CITY OF WISCONSIN DELLS MEETING AGENDA

Meeting Description DESIGN REVIEW COMMITTEE

Date: WEDNESDAY, APRIL 5, 2017 Time: 10:00AM Location: MUNICIPAL BUILDING - 300 LA CROSSE STREET, WISCONSIN DELLS, WI

DRC 04/05/17

① Front Facade Rendering
 3/16" = 1'-0"

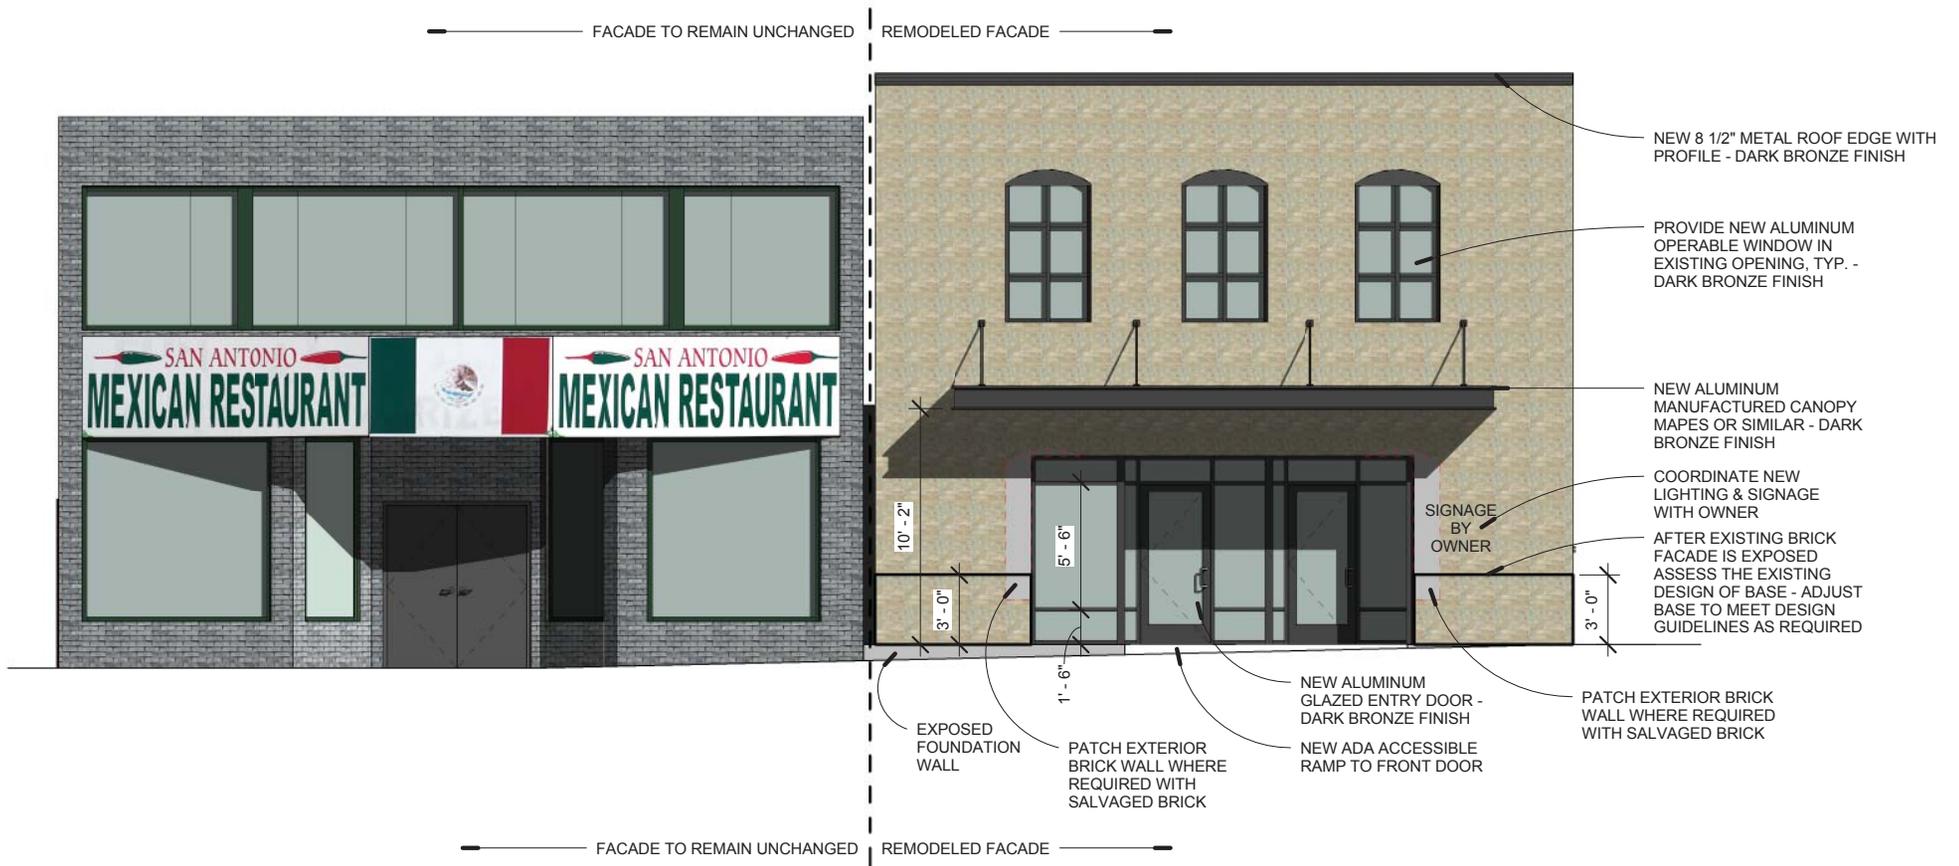
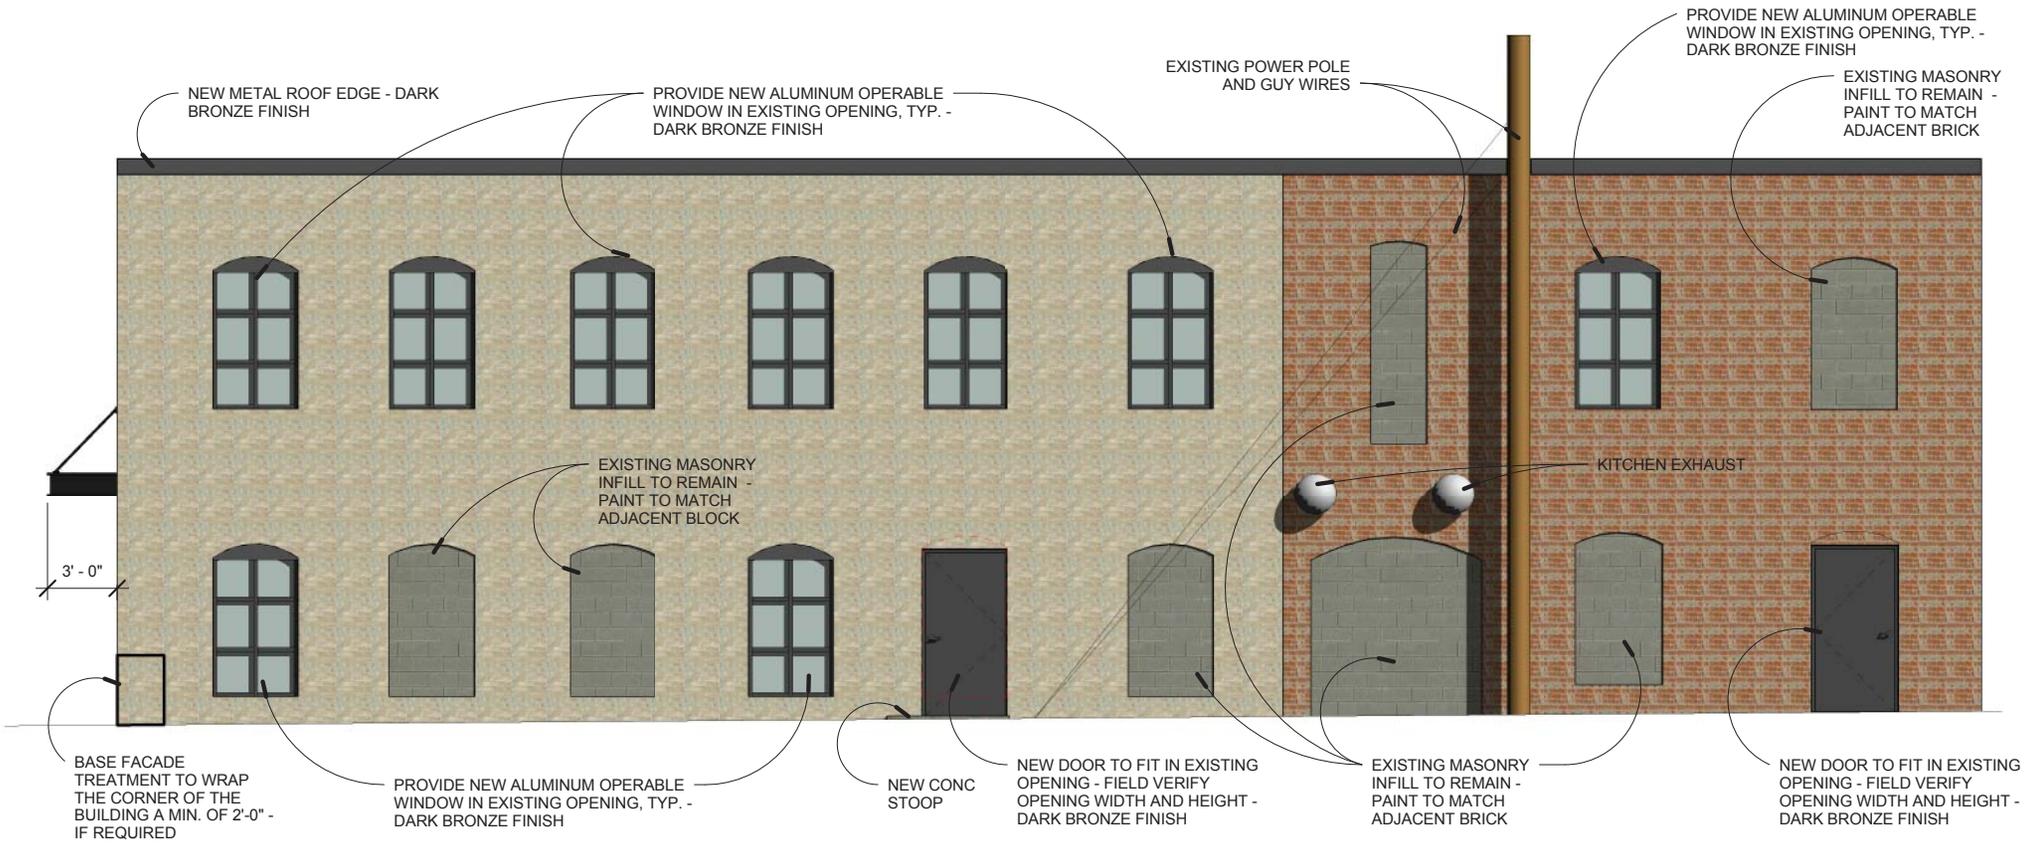
- **Standard #5 (Scale, Articulation, & Roofline Section – P28):** A discernable “base” has not been established. The standard requires this base to include at least the first two feet of the building and up to the entire first floor. Generally, this is done by including a different material and/or color to differentiate between base and middle. Ideally this transition between the different material/color would have at least a 1.5-inch relief from the primary brick wall with the base at least wrapping around the corner the building enough to not seem as if the base material is just pasted on the building (i.e., the base shows up on the side/alley at least initially). In some cases, the base could be established by only changing the brick patterning/style (left image below). *

** Note: Standard 4 (Scale, Articulation, & Roofline Section – P28) requires a horizontal expression line between the first and upper floors; however, this is only for NEW buildings. Therefore, this is not a requirement in the case of a façade improvement of an existing building. However, it could be a way to establish a base to the building.*

- **Standard #5 (Projections – P31):** The marquee above the entrance does not provide a 10-FT vertical clearance. This intent of this standard is to allow for pedestrian-scaled signage to exist below the overhang structure now or in the future. Awnings are allowed to be lower as they generally will include signage right on the fabric awning. The 8 FT 2 IN clearance should be increased. *If a waiver is considered by the DRC, the marquee should at least be raised to match the bottom of the adjacent “San Antonio Mexican Restaurant” marquee. However, the waiver request is on the applicant to prove the reduction in vertical clearance meets one of the three waiver scenarios outlined on page 5 (in the side bar).*

- Recommendation ‘H’ (Scale, Articulation, & Roofline Section – P28): A unique and decorative cornice design is encouraged to generate character and building identity. *Current proposal does establish a “top” to the building; however, this could be enhanced with further design consideration.*

Item 4(c) & 5(a) Creperie Façade 116 ½ Broadway.

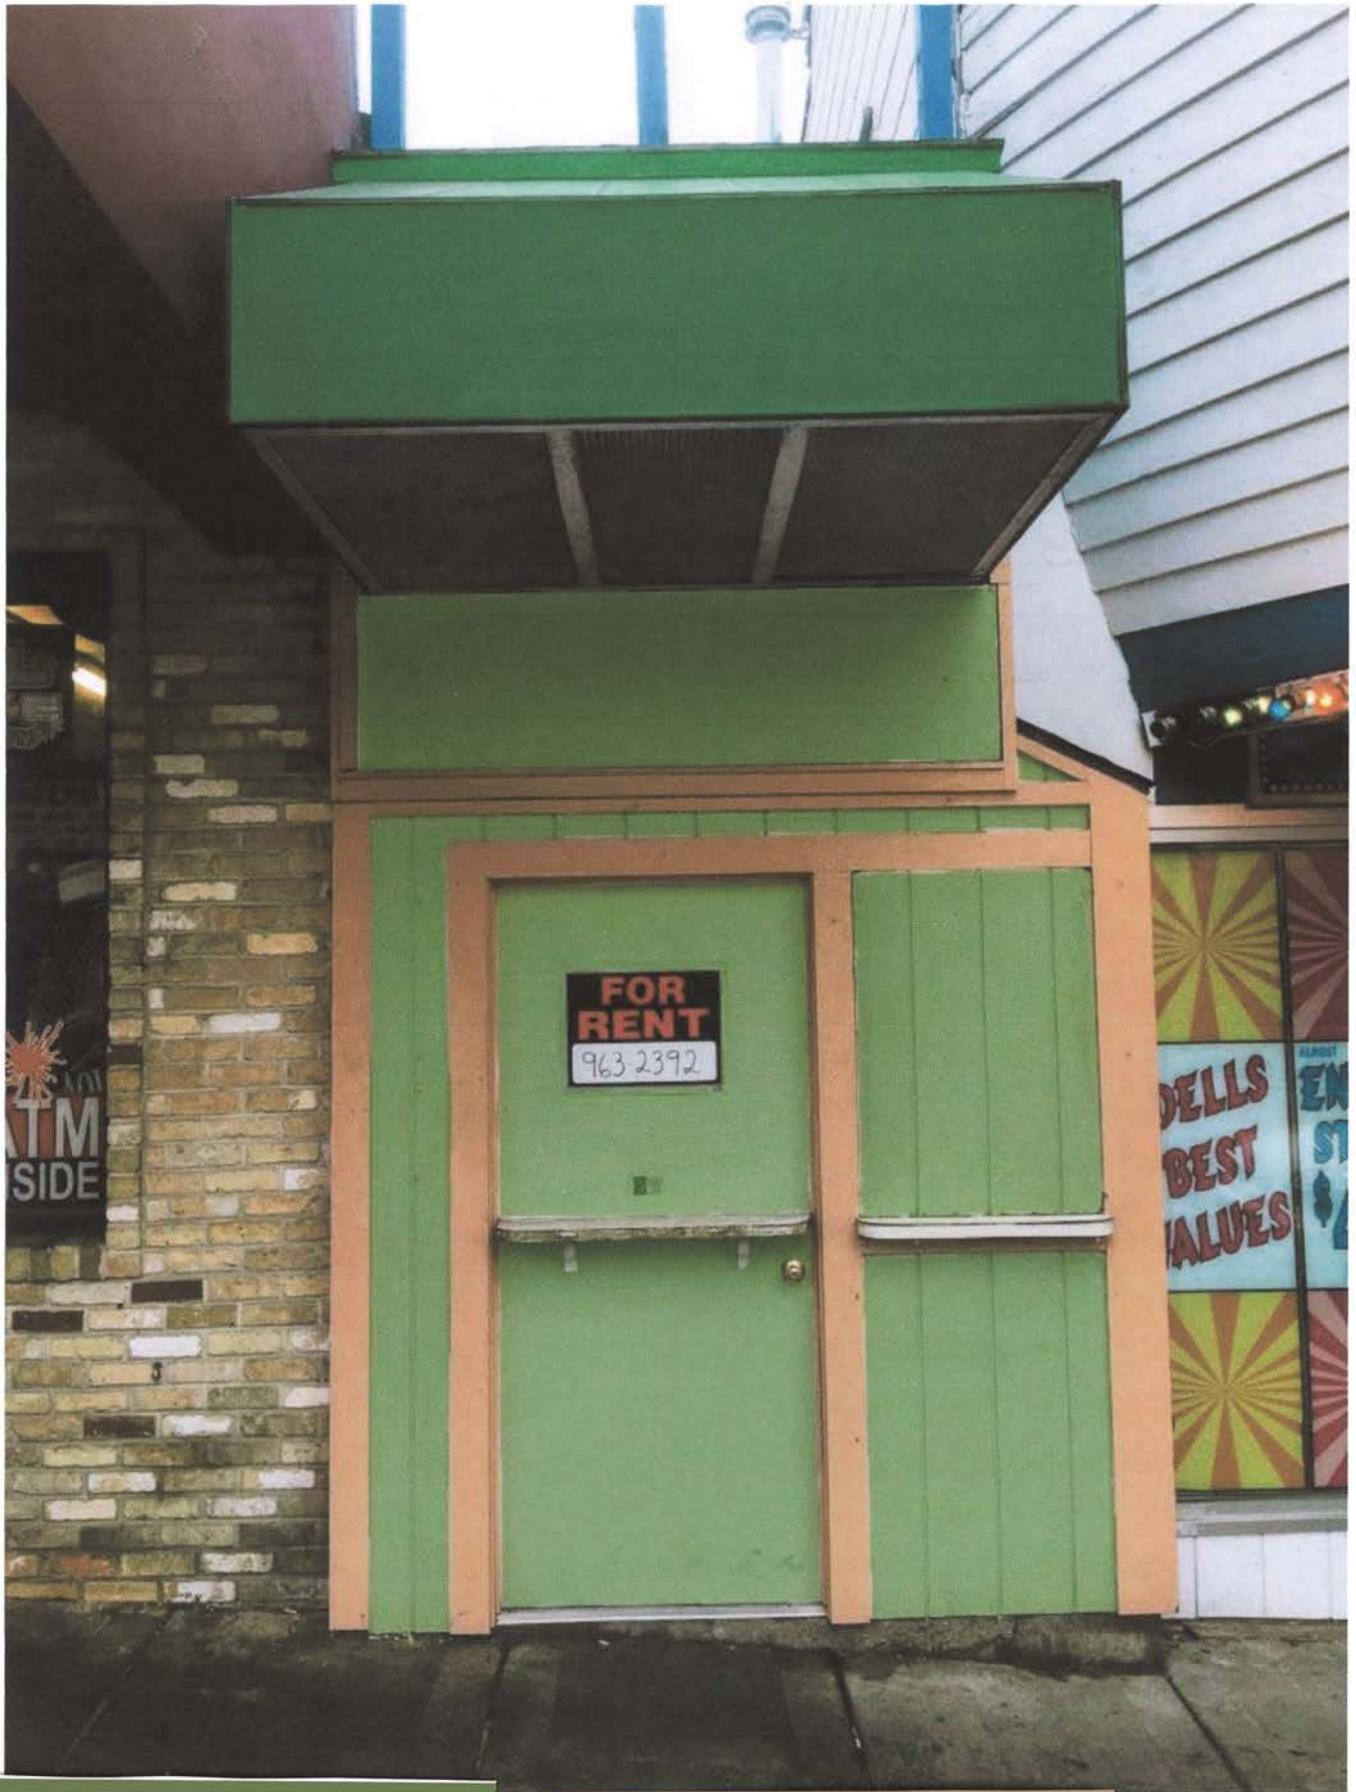
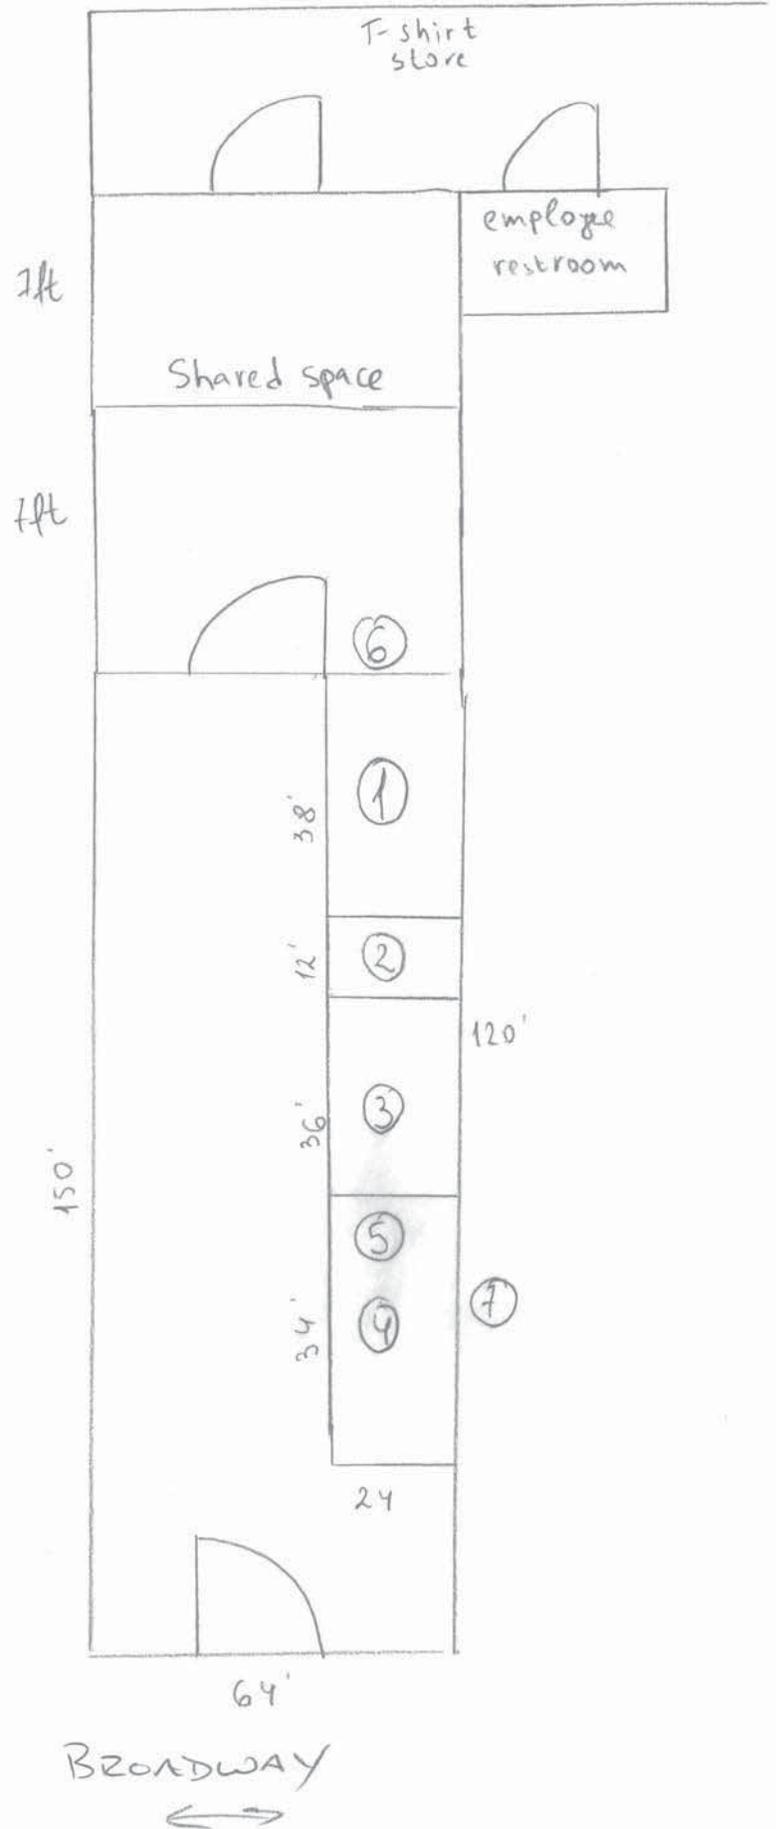
The applicant would like to meet any façade design standards, so they will recover the existing awning with the Gingko sunbrella fabric color designated for the 100 block. They have also presented color schemes for the building exterior that they hope will complement the awning.

In an effort to fully conform to the design standards, the applicant would like to apply a natural brick veneer to the base of the building. The applicant is working on a rendering for the committee to review and hopes to have something completed that they can bring to the meeting.

Due to this location between two existing buildings, the applicant has agreed to ensure that a 3ft wide clear path always be maintained in their space to ensure emergency response personnel have clear access if required
